AGENDA
CITY OF KENTWOOD PLANNING COMMISSION
TUESDAY, FEBRUARY 13, 2024
KENTWOOD COMMISSION CHAMBERS
4900 BRETON AVENUE, SE
7:00 P.M.

STAFF REPORT: February 6, 2024
PREPARED FOR: Kentwood Planning Commission
PREPARED BY: Joe Pung
CASE NO.: 05-24 Vanderwall Builders

STAFF REPORT: January 9, 2024
PREPARED FOR: Kentwood Planning Commission
PREPARED BY: Lisa Golder
CASE NO.: 3-24 Breton Ravines

Exhibit 5: Existing Product Display in the Front Yard

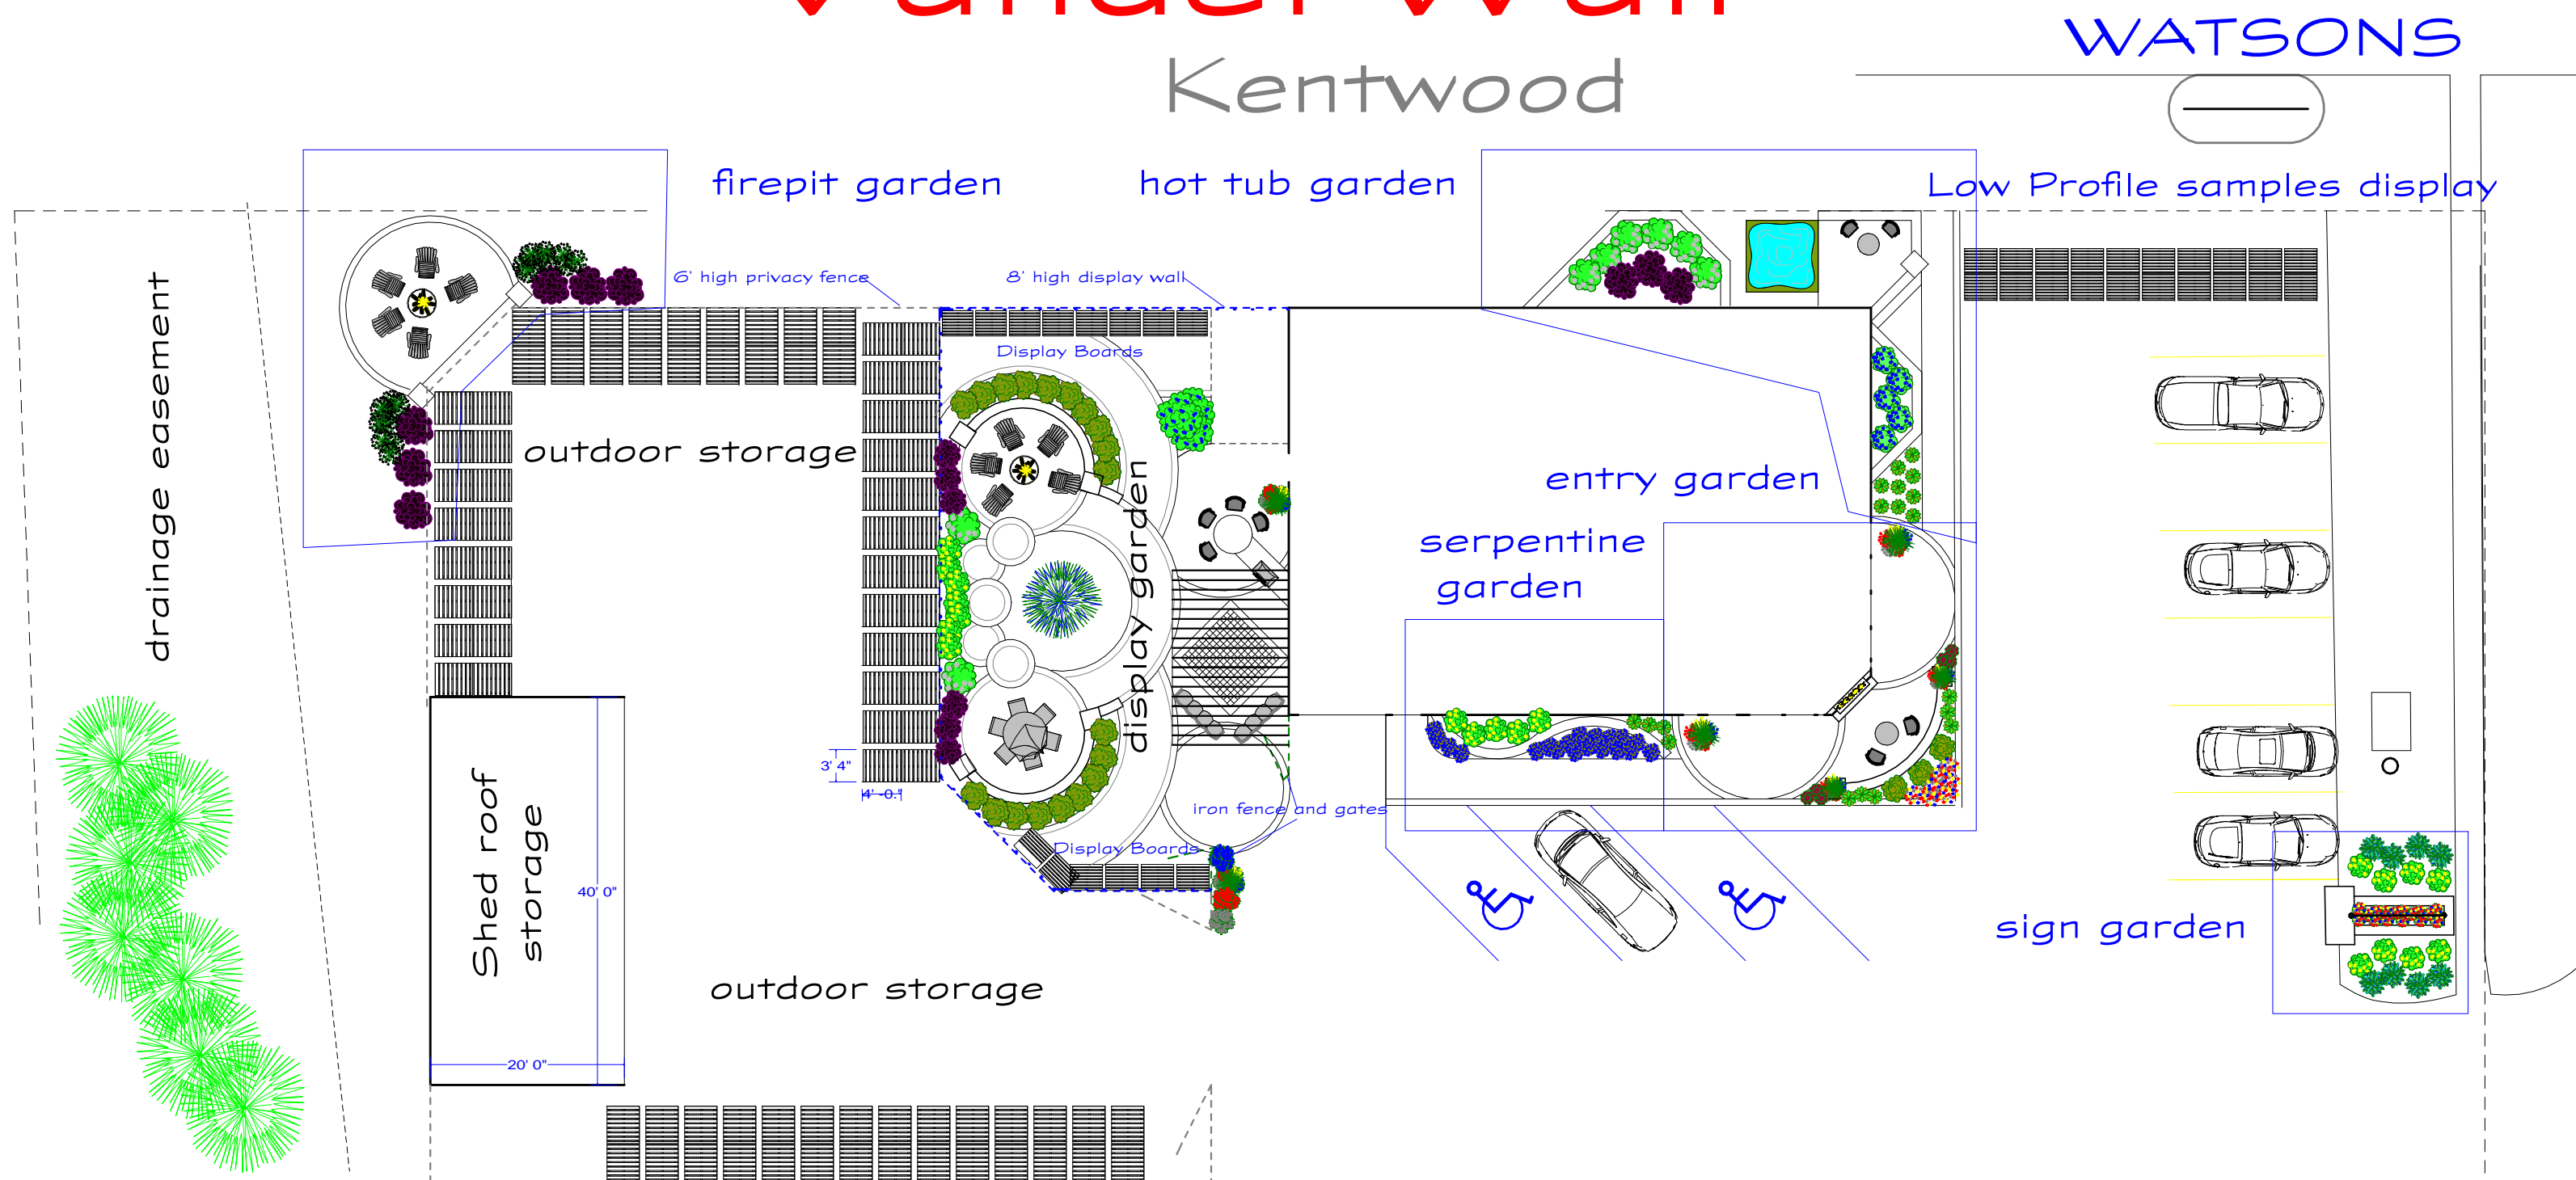
- 4) There is currently a product display in the front yard of the site (see Exhibits 4 and 5) and the proposed site plan depicts a low profile sample display in the same location; such a display in the front yard is not permitted and could also present an issue with vehicle and pedestrian conflicts in the parking lot.
